ADDENDUM
NO. 3

July 31, 2020

Additions & Renovations to Lawrence North High School
7802 Hague Road
Indianapolis, IN 46256

PREPARED BY SCHMIDT ASSOCIATES FOR:
LAWRENCE NORTH HIGH SCHOOL RENOVATION
LAWRENCE TOWNSHIP, M.S.D. OF

A. **Drawing Number CL106**

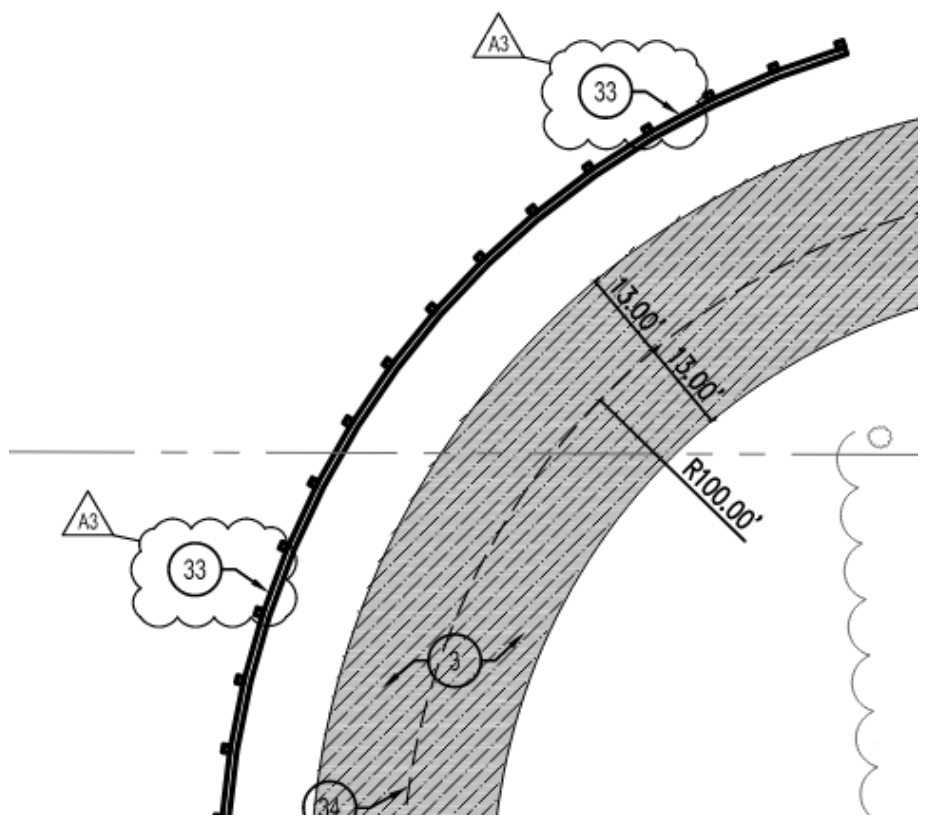
1. MODIFY Drawing CL106 as shown below:

Revise keynote indicating steel backed timber guardrail from number “34” to number “33,” as shown below. There are 5 instances of this revision on this sheet.

A. **Drawing Number SF1AL**

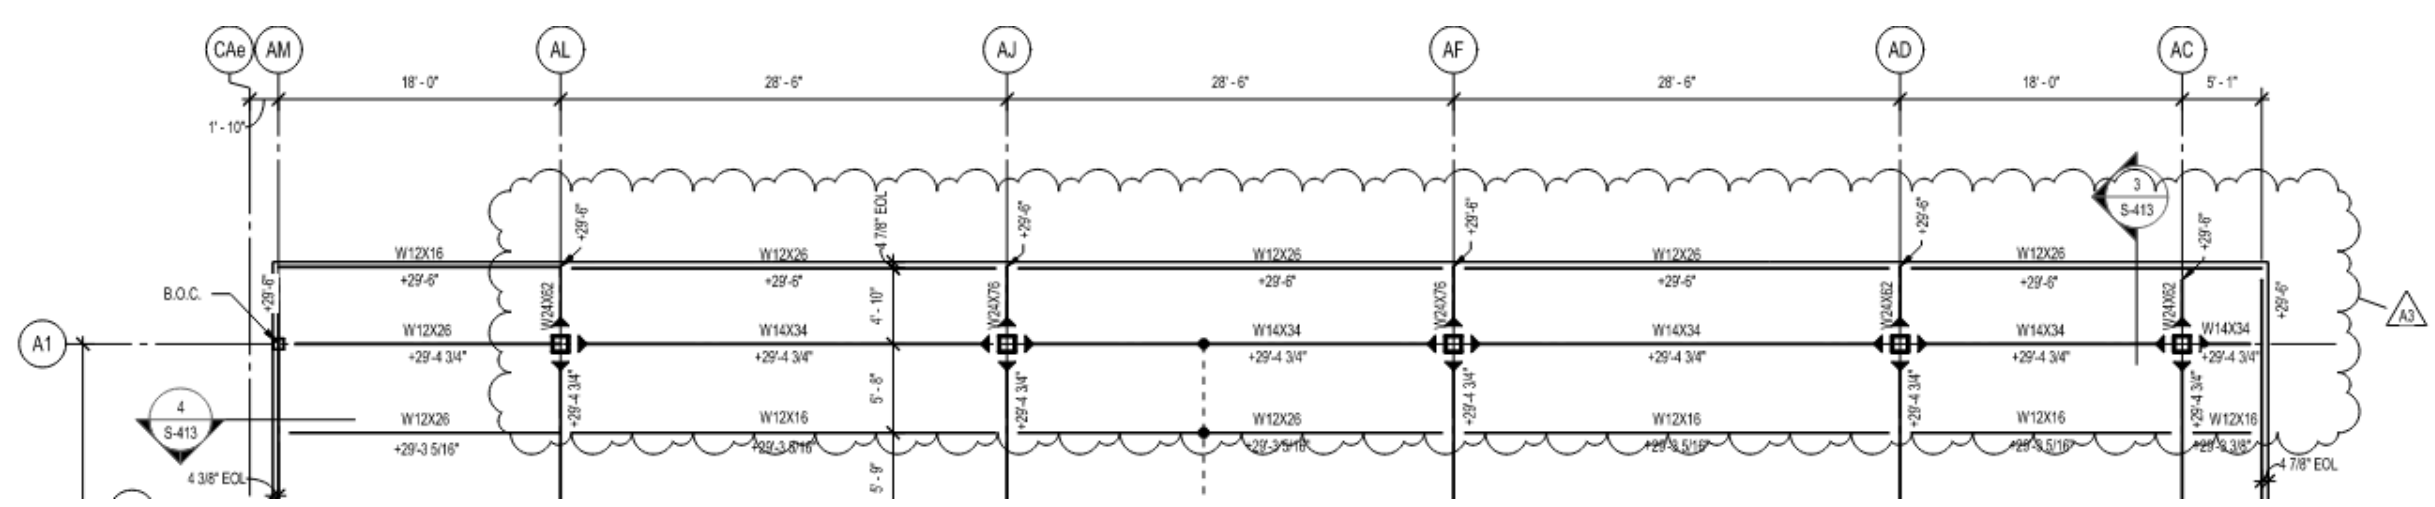
1. In 1/SF1AL, modify the arrangement of beam-to-column connections on column line A1, as shown below:

C. **Drawing Number AF1C1**

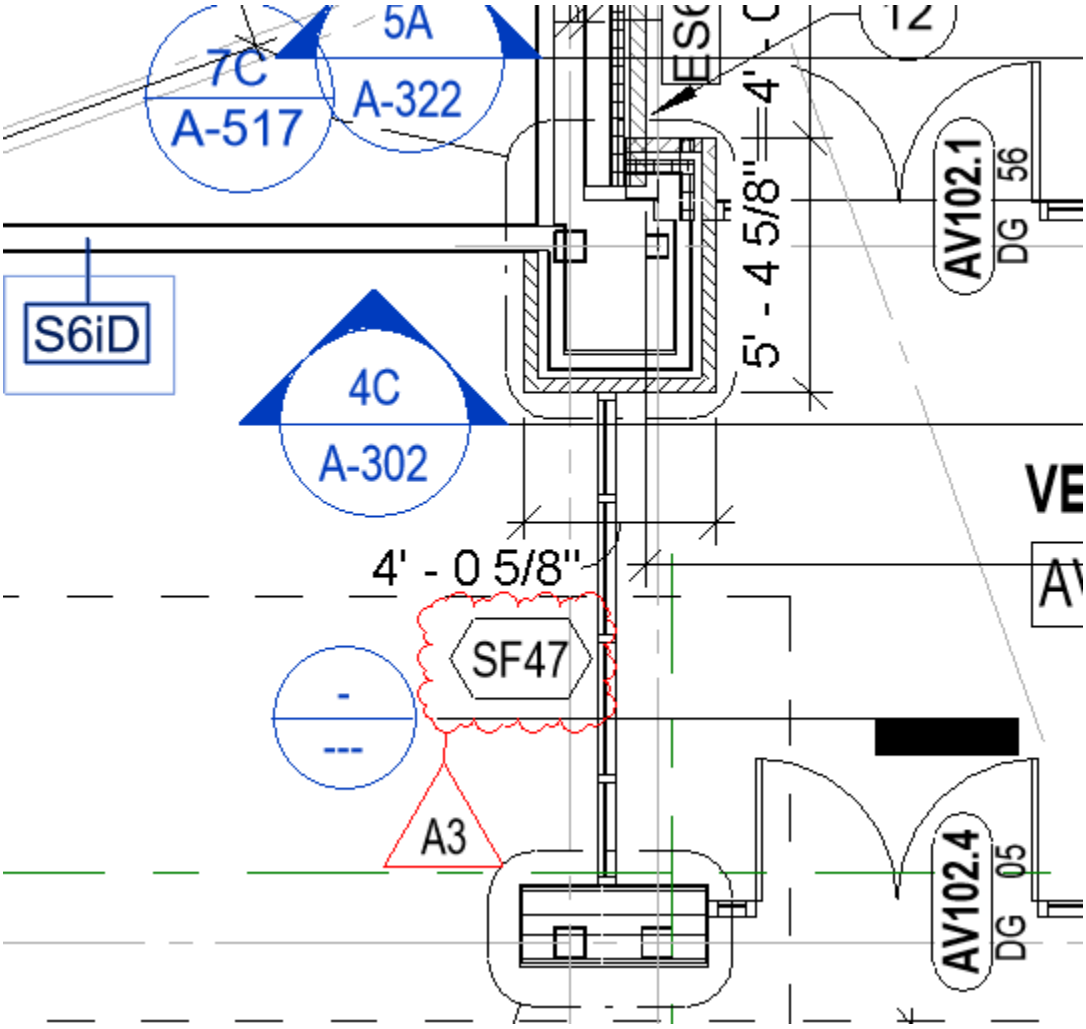
1. MODIFY Drawing 2A as shown below:

F. **Drawing Number A-604**

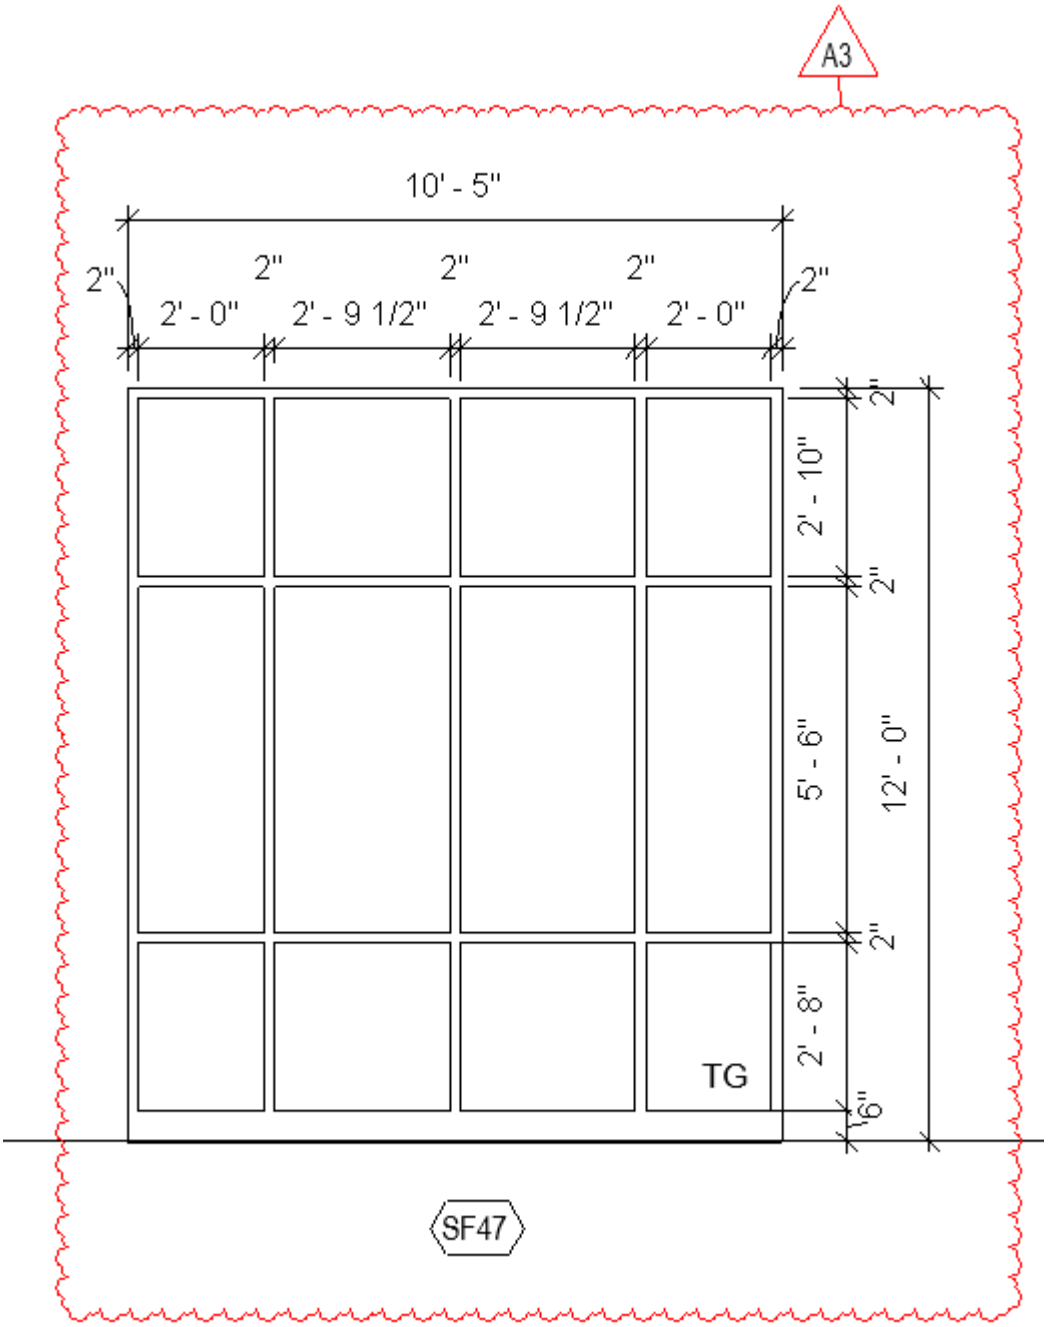
1. MODIFY Elevation SF47 as shown below:

A. **Drawing Number I-201**

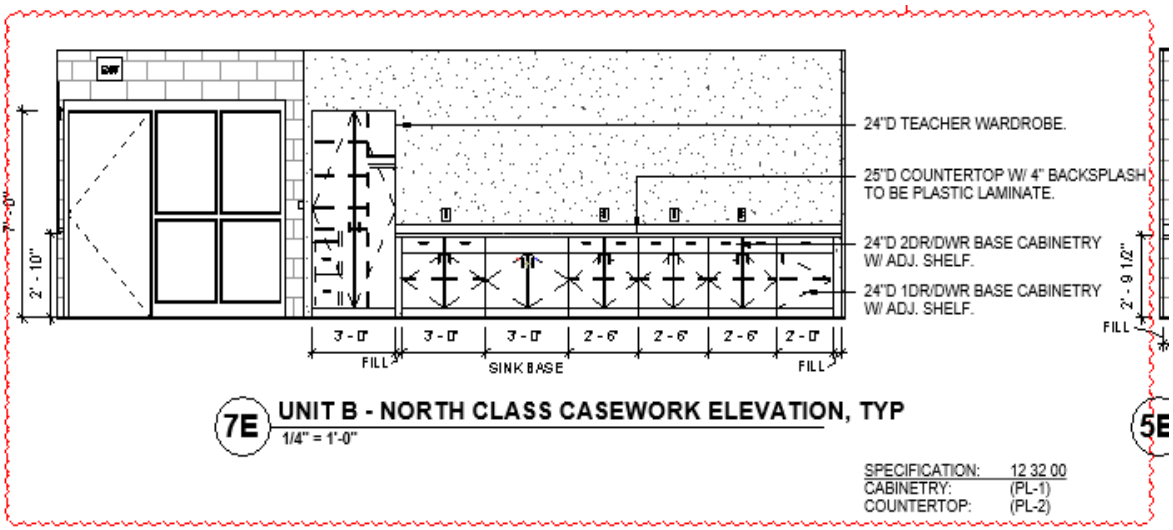
1. INSERT Elevation 7E as shown below:

F. **Drawing Numbers IN1B1, IN1B2, IN1B3**

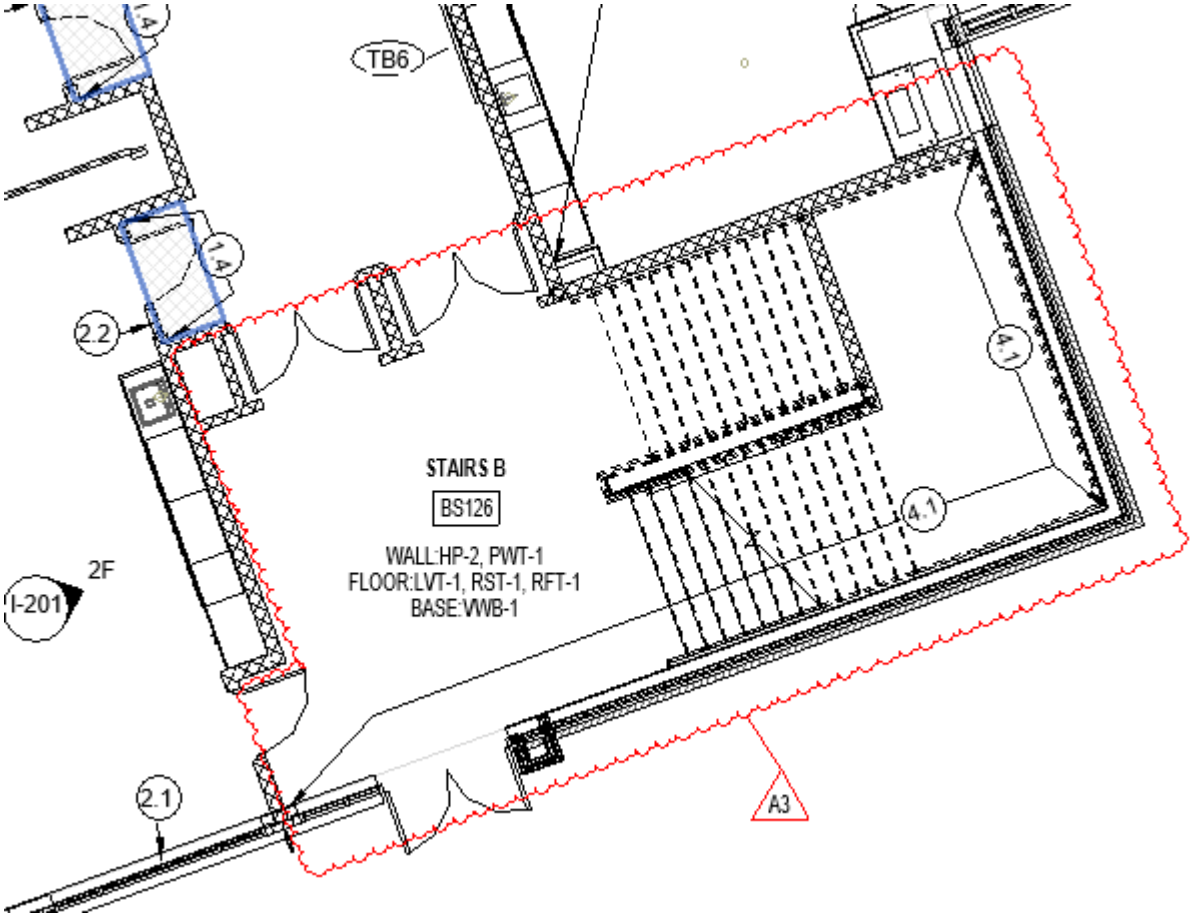
1. MODIFY Plan Note leader 4.1 as shown below:

A. Drawing Number M-505

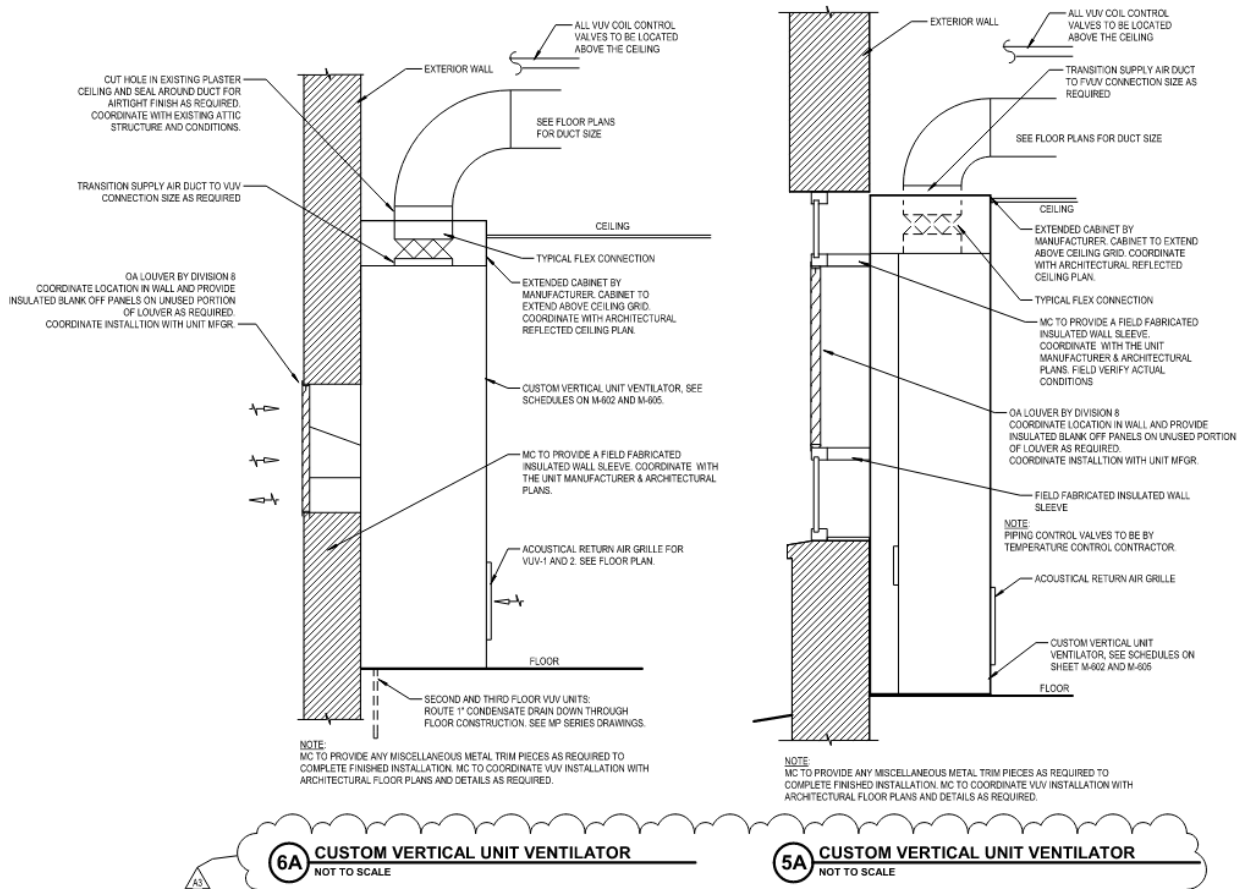
1. MODIFY Details 5A and 6A as follows:

Miscellaneous clarifications to details and removed references to existing architectural features as shown below:

C. **Drawing Number MP1A1**

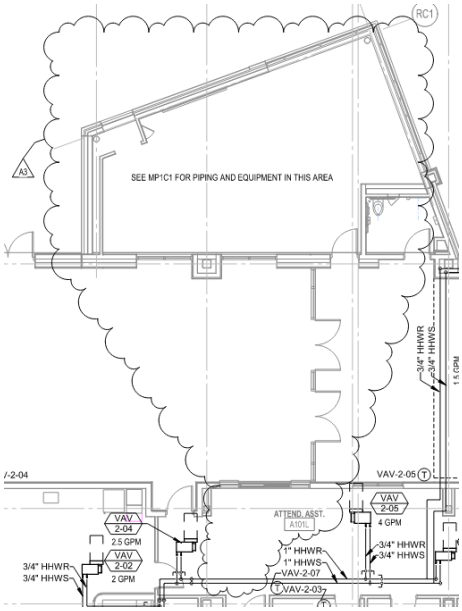
1. MODIFY Drawing as shown below: Delete redundant scope which is covered in MP1C1 sheets

D. **Drawing Number MH1D2**

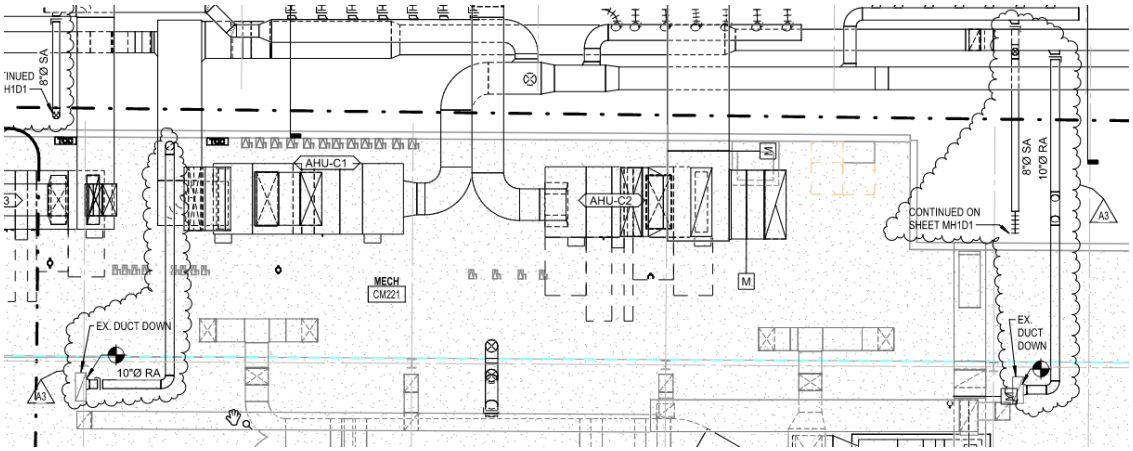
MODIFY Drawing as shown below: Added ductwork to AHU-C1 system to serve corridor areas below. Also clarified view reference on this sheet.

F. **Drawing Number MH1E2**

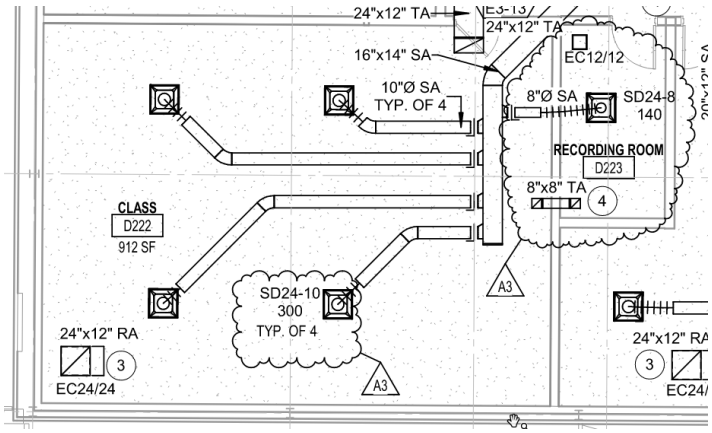
MODIFY Drawing as shown below: Adjusted ductwork and air balancing.

H. **Drawing Number MH1D1**

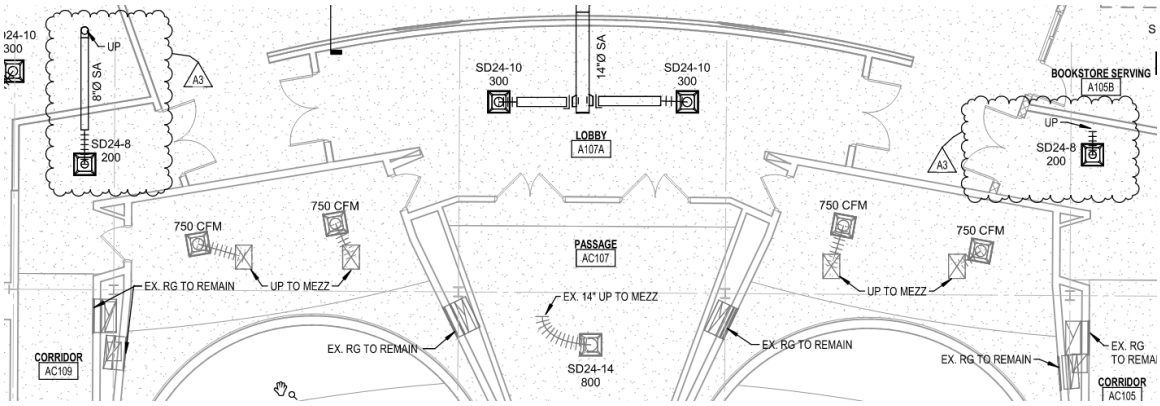
1. MODIFY Drawing as shown below: Continuation from MH1D2 modifications. Added diffusers in these spaces.

I. **Drawing Number M-402**

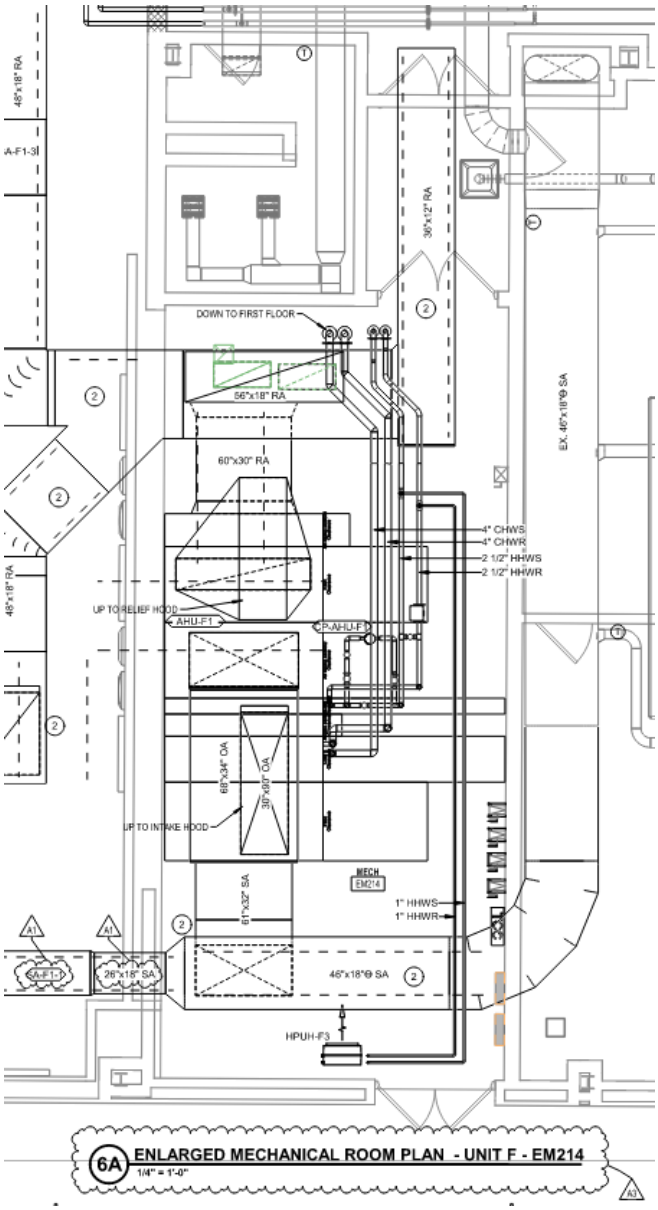
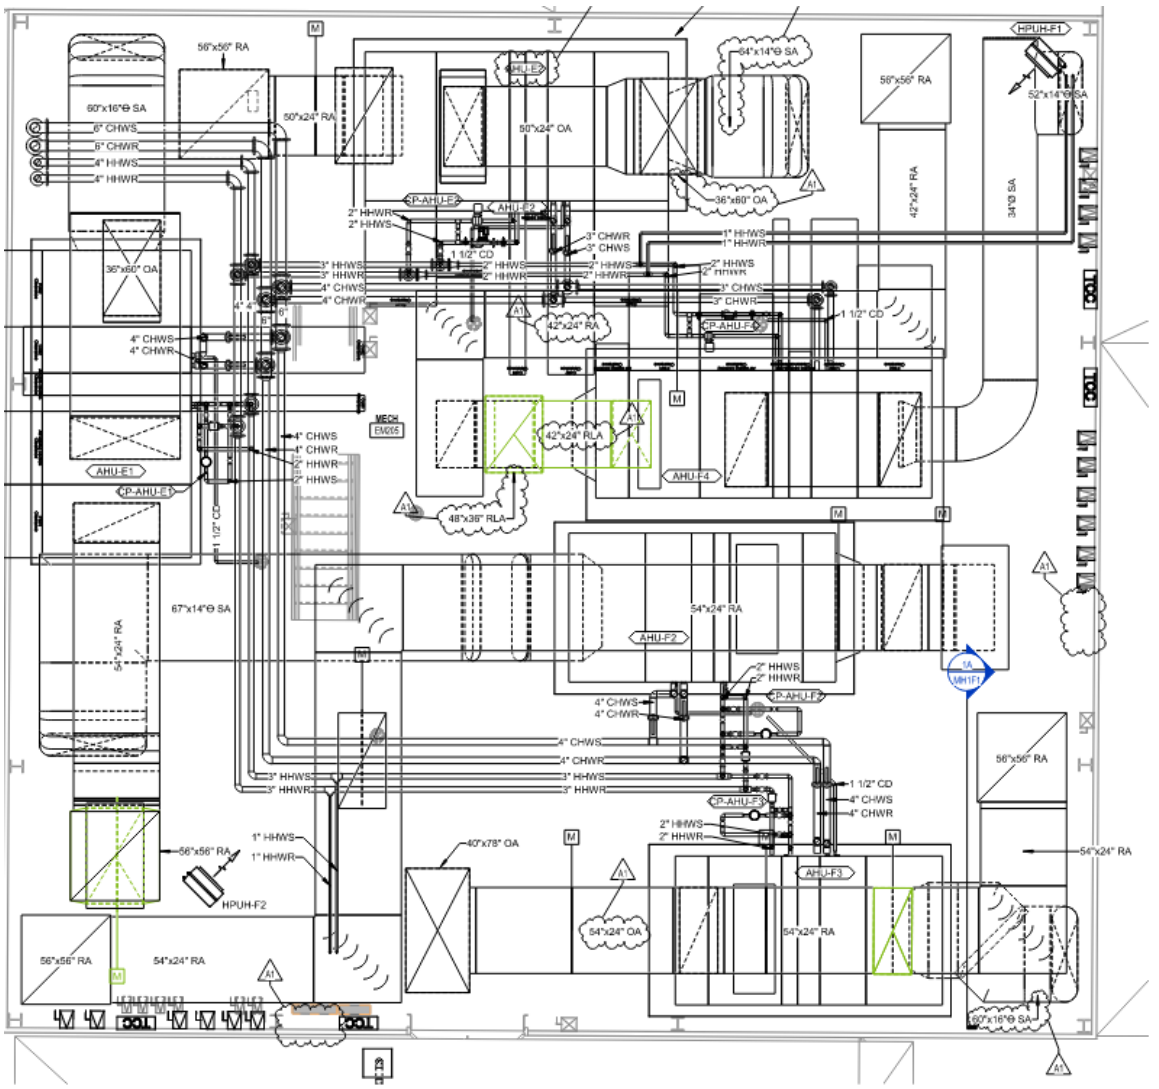
1. MODIFY Drawing as follows: Miscellaneous dimensions and clarifications to duct and pipe sizes on views 6A and 2A as shown below:
